P-14921

ISSUE-2

JINDAL ALUMINIUM LTD.
 BANGALORE-560073 (INDIA)

PARTY'S NAME	KARAM DASS NIRASH, MANDI
PARTY'S DRAWING No.	HW-4
ALLOY & TEMPER	6063 T6
DESCRIPTION	WINDOW SECTION

S4576

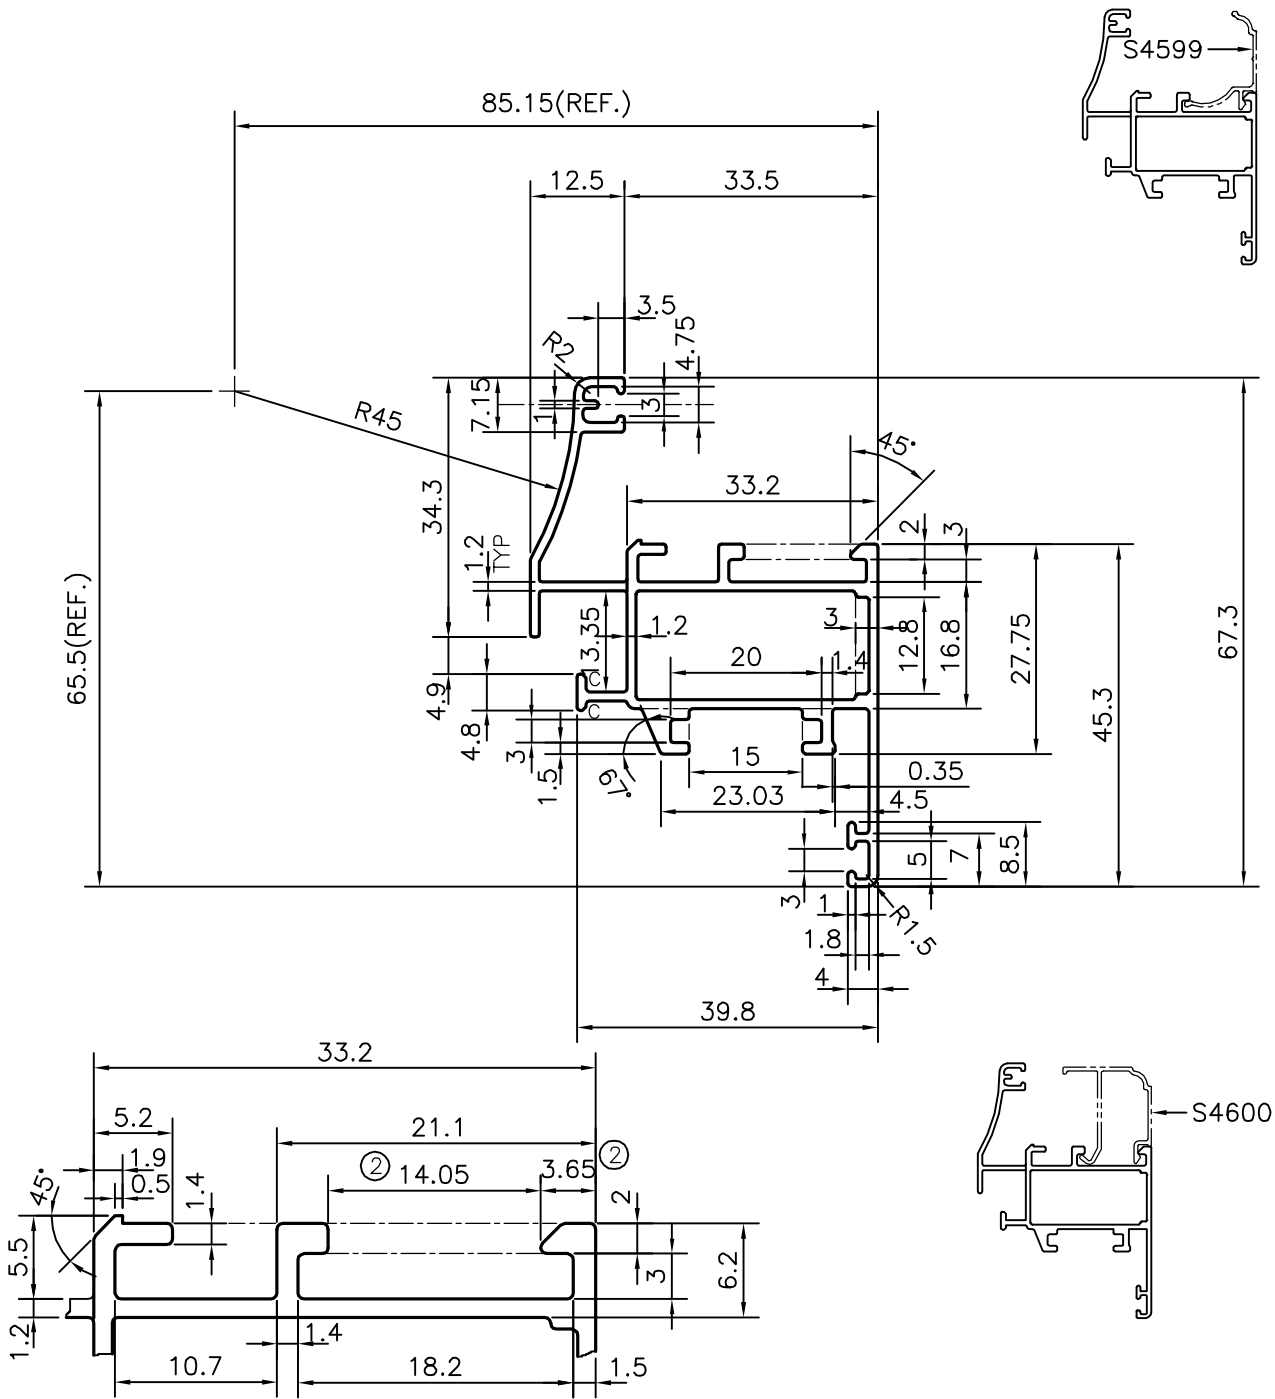
DIMENSIONS CHANGED FROM 3.5 TO 3.65 & 14.2 TO 14.05
 WEIGHT ALSO CHANGED FROM 0.842 Kg/m TO 0.841 Kg/m
